UNITED STATES ENVIRONMENTAL PROTECTION AGENCY

Re: PCB Cleanup and Risk-Based Disposal Approval under 40 CFR §§ 761.61(a) and (c)
English Station Parcel A / New Haven, CT

**PCB CLEANUP AND RISK-BASED DISPOSAL APPROVAL CONDITIONS
ENGLISH STATION PARCEL A (“the Site”)
510A GRAND AVENUE
NEW HAVEN, CONNECTICUT**

FIGURE 9
UNITED ILLUMINATING ENGINEERING STATION POWER
PLANT
510A GRAND AVENUE, NEW HAVEN, CONNECTICUT
**PARCEL A FINAL SITE CONDITIONS AND
GRADING**
NOVEMBER 2018 REVISED DECEMBER 2019 SCALE: 1"=30'

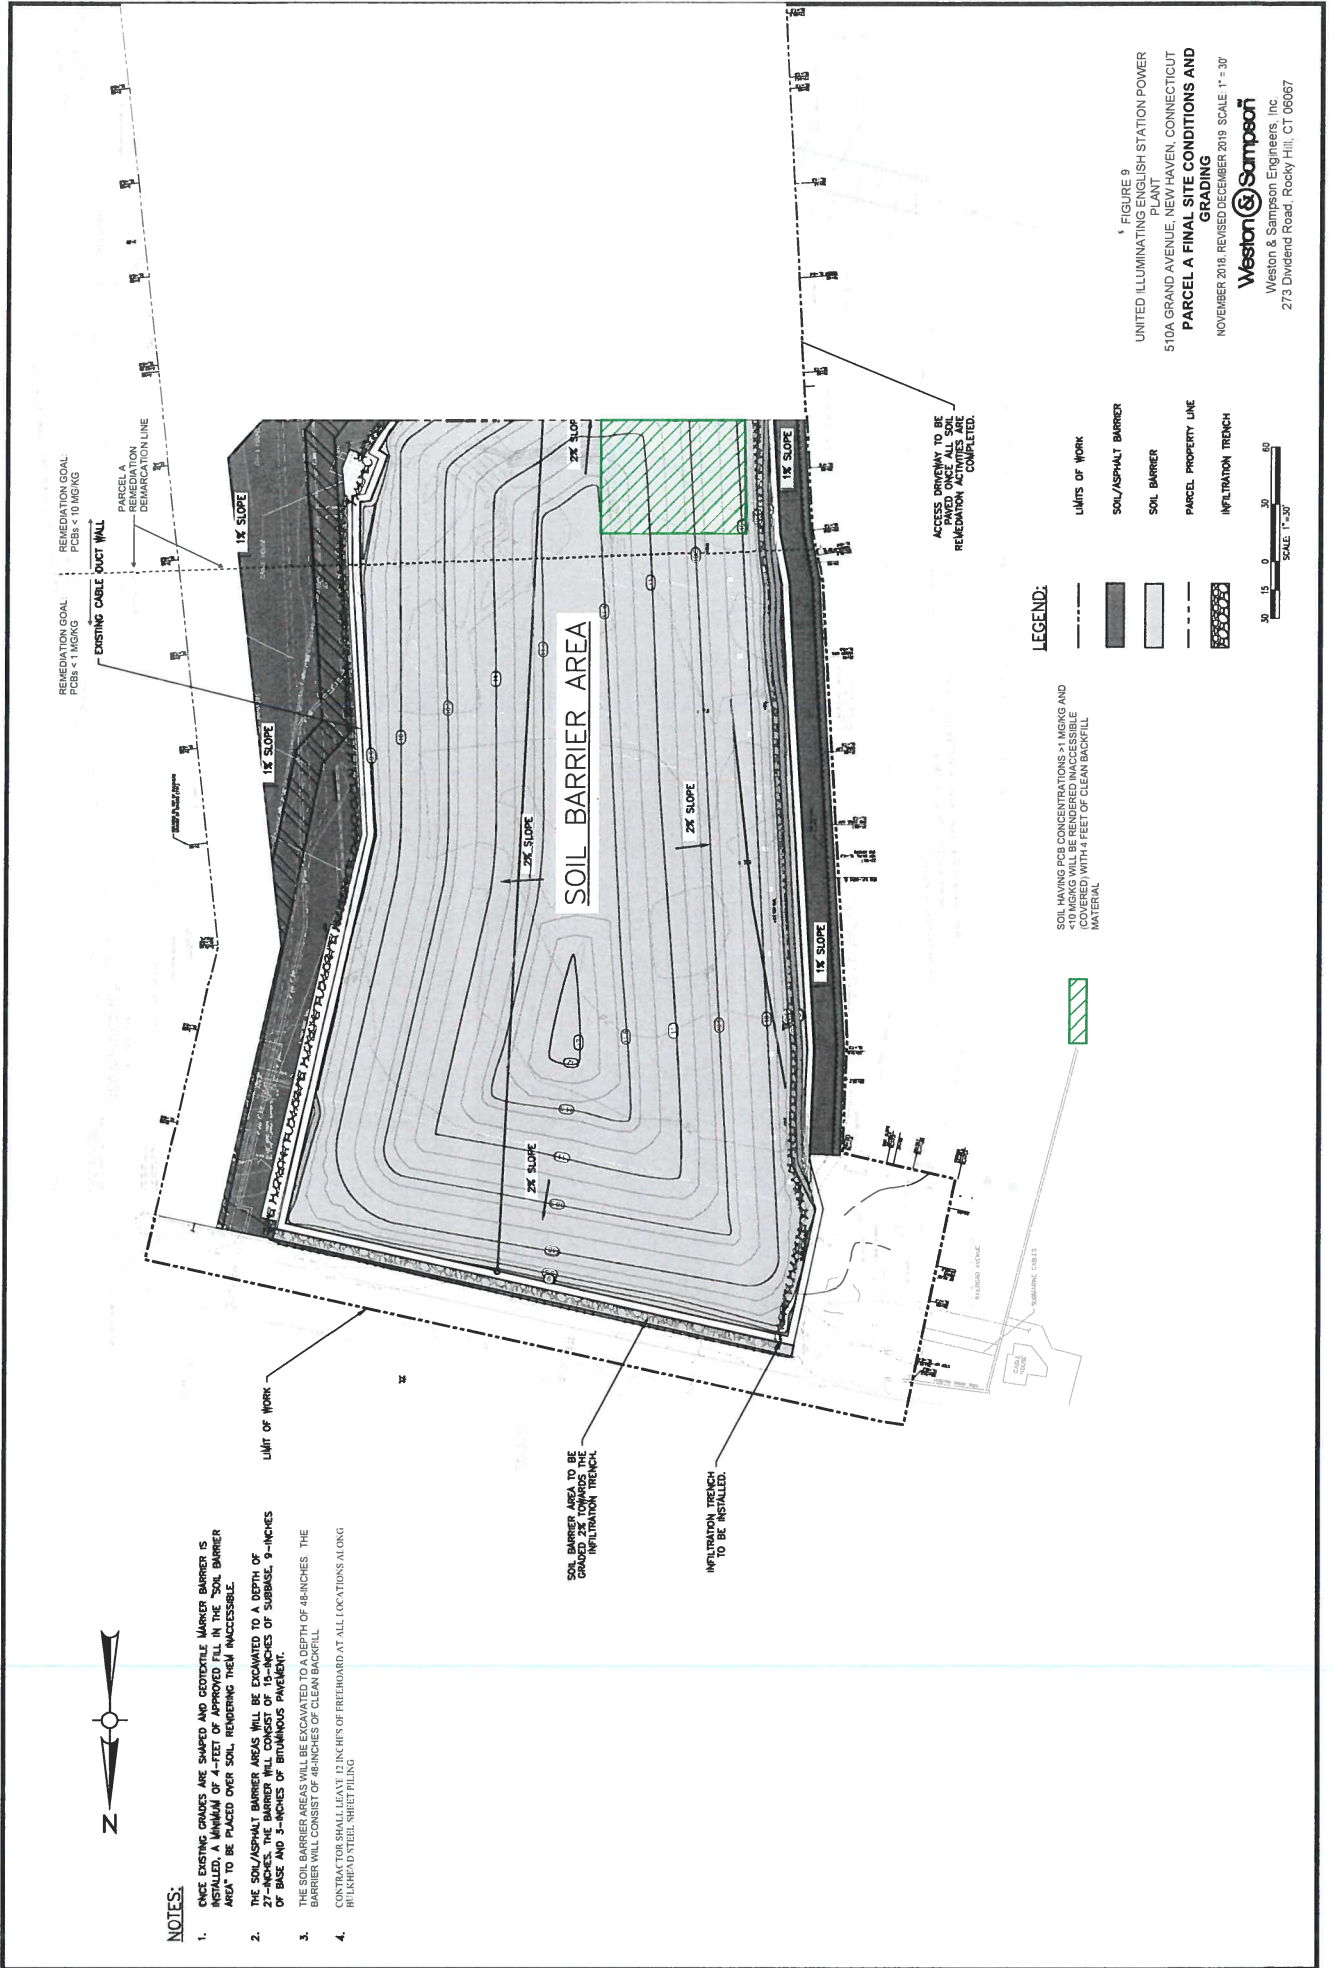
10. Construct a clean cover comprised of an orange geotextile, and a minimum 4-feet of clean soil or a 2-feet clean soil cover overlain with a minimum 3 inches of bituminous concrete, over > 1 ppm but ≤ 10 ppm *PCB remediation waste* and over subsurface concrete where the requirements under 40 CFR § 761.30(p) for *Continued use of porous surfaces contaminated with PCBs regulated for disposal by spills of liquid PCBs* are implemented. Attachment 4, and;
11. Record a deed notice in accordance with 40 CFR § 761.61(a)(8) to document PCB concentrations remaining at the Site and any use restrictions and cap maintenance requirements.

- a. The PCB cleanup standard shall be less than or equal to (“≤”) 10 ppm to the south of the demarcation line as shown on Attachment 2. *PCB remediation waste* with greater than (>) 1 ppm but ≤ 10 ppm shall be covered with an orange geotextile fabric overlain with: (1) a minimum 4-foot clean soil cover or; (2) a minimum 2-foot clean soil cover overlain with a minimum 3 inches of bituminous concrete, in compliance with the Connecticut Department of Energy and Environmental Protection Remediation (“CTDEEP”) Regulations.
